Form C-103
Jun 19, 2008

WELL API NO. 30-045-08640
5. Indicate Type of Lease STATE <input type="checkbox"/> FEE <input checked="" type="checkbox"/>
6. State Oil & Gas Lease No. FEE
7. Lease Name or Unit Agreement Name Fifield 5
8. Well Number 1
9. OGRID Number 217817
10. Pool name or Wildcat Basin Dakota

The subject well is part of the proposed Mangum SRC 1 P&A program. The attached revised procedure replaces the procedure filed with the P&A NOI submitted on 3/31/2016.

ConocoPhillips
FIFIELD 5 1
Expense - P&A

Schematic - Proposed

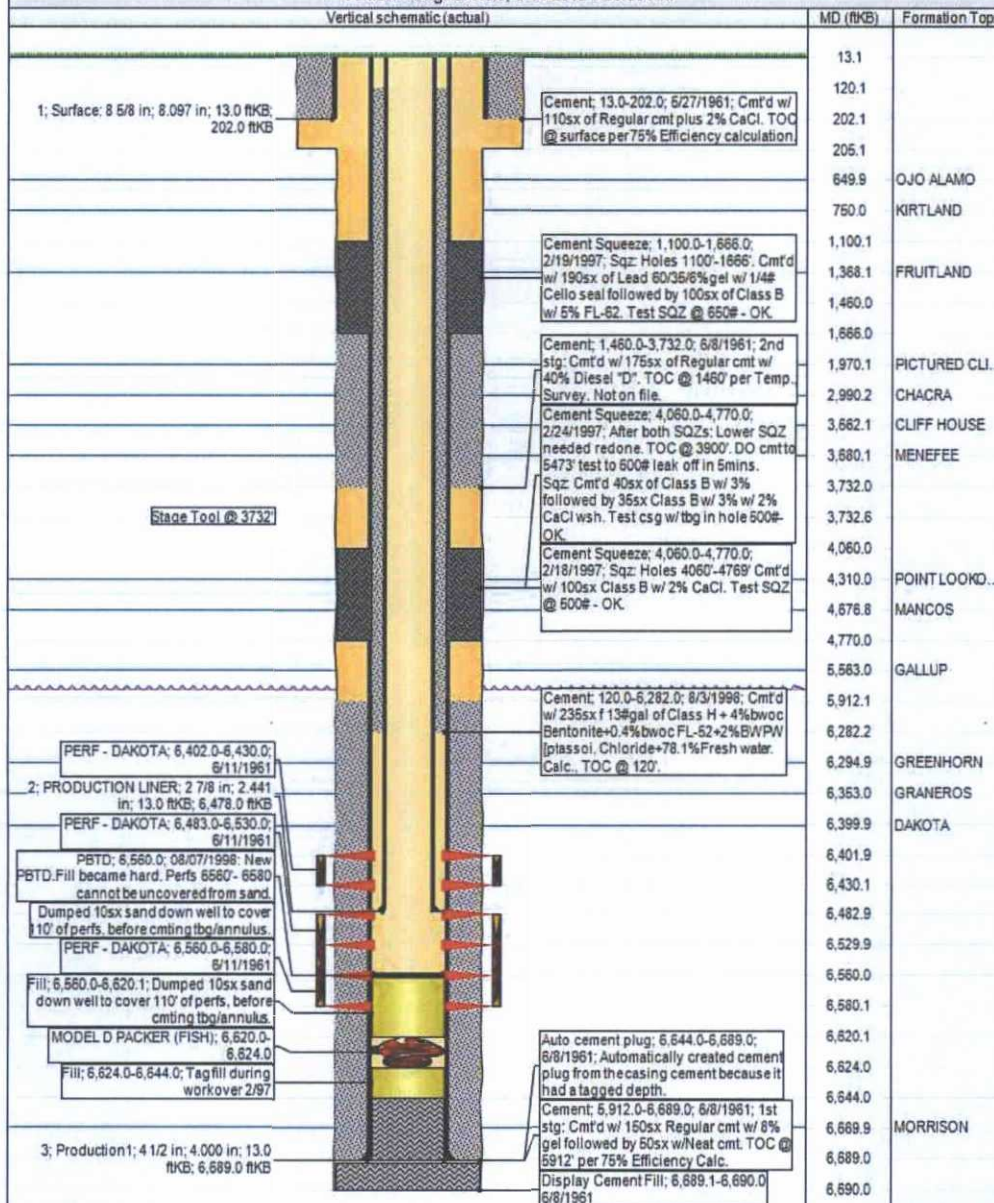
* Move fruitland plug to 1530'-1630'

14. Plug 6 - Fruitland Formation Top, ~~4348' - 4448'~~ ^{1530' - 1630'} 5 Sacks Class B Cement
